Sequoyah Nuclear Plant, Units 1 and 2
Facility Operating License Nos. DPR-77 and DPR-79
NRC Docket Nos. 50-327 and 50-328

Subject: Response to NRC Request for Additional Information Regarding the Review of the Sequoyah Nuclear Plant, Units 1 and 2, License Renewal Application, Sets 10 (B.1.23-2a), 11 (4.1-8a), and 12 (30-day) (TAC Nos. MF0481 and MF0482)

Tennessee Valley Authority
Sequoyah Nuclear Plant, Units 1 and 2 License Renewal
TVA Responses to NRC Request for Additional Information:
Sets 10 (B.1.23-2a) and 11 (4.1-8a)

EXHIBIT A: TYPICAL TEST CONNECTION DETAIL

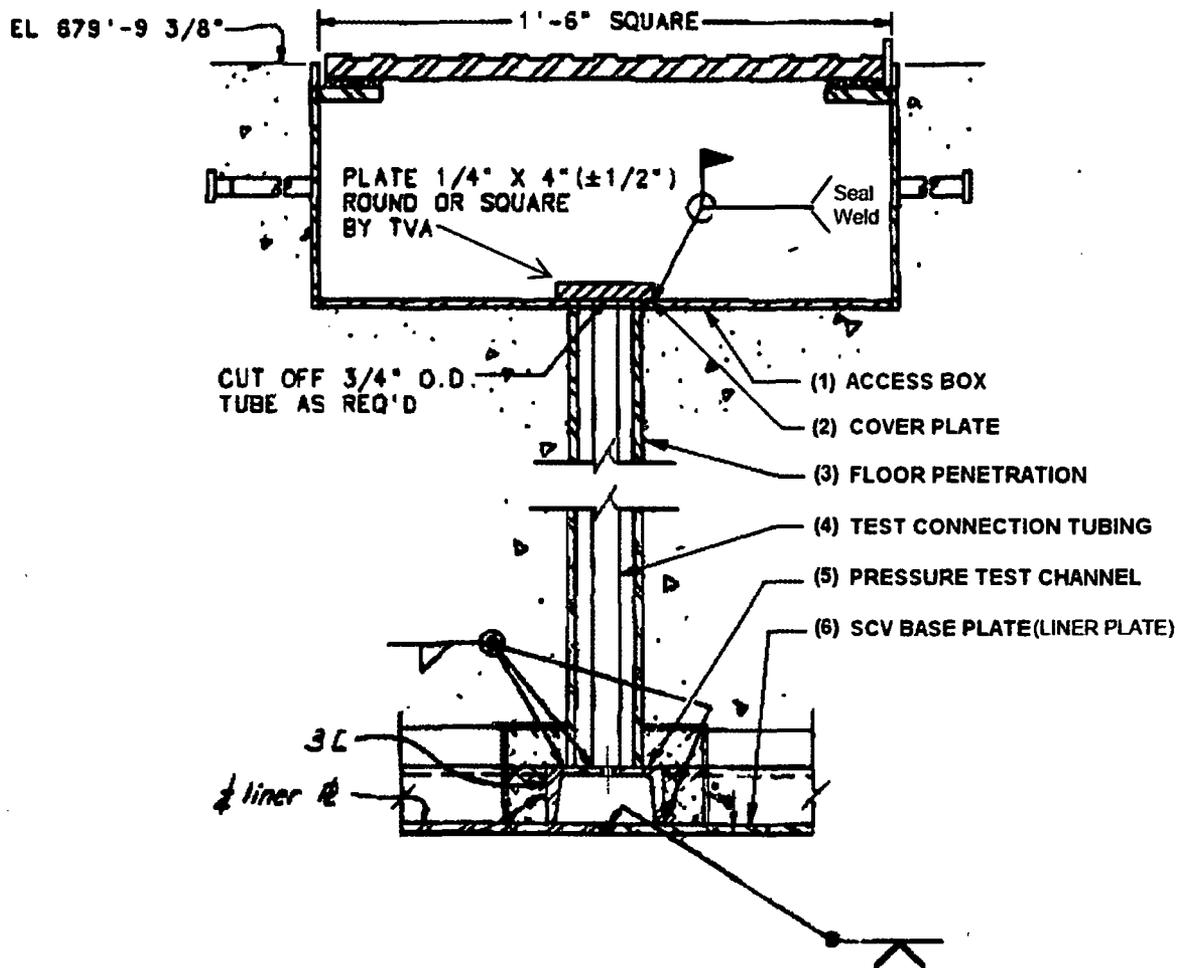
- 1. Explain how the design modification, shown in exhibit A, will be effective in sealing the leak chase channels from moisture intrusion during the period of extended operation. Furthermore complete exhibit A, shown in RAI B.1.6-1, with a code approved weld type, weld-size, and weld symbol continued to be used for welding the cover plates to the access box steels.*

1. At SQN, visual inspection in 2012 identified standing water and corrosion on the inside surfaces of the ¼-inch thick carbon steel access boxes (Item 1 of Exhibit A) and the base slab floor penetrations (Item 3 of Exhibit A). The more significant corrosion, including through-wall corrosion at several locations, was identified on the thin-walled ¾-inch diameter carbon steel pressure test connection tubing (Item 4 of Exhibit A) beneath the bottom plate of the access box. This location was most susceptible to corrosion because any water that bypassed the access box lid gasket drained into the annular area between the floor penetration pipe (Item 3 of Exhibit A) and the test connection tubing (Item 4 of Exhibit A), where it could be in contact with the outside surface of the ¾-inch diameter test connection tubing. Based on these findings, the original design configuration of SQN Unit 2 was modified so that the test connection tubing no longer served the function of preventing moisture from entering the pressure test channel (Item 5 of Exhibit A). The corroded test connection tubing was cut off below the access box (Item 1 of Exhibit A) and abandoned in place. A ¼-inch carbon steel plate (Item 2 of Exhibit A) was welded over the floor penetration pipe (Item 3 of Exhibit A). A non-structural seal weld was applied, as depicted in Exhibit A, to eliminate possible moisture intrusion into the test connection tubing and the floor penetration. As required by SQN welding procedures, the surfaces were cleaned by grinding to base metal and visually inspected prior to welding.
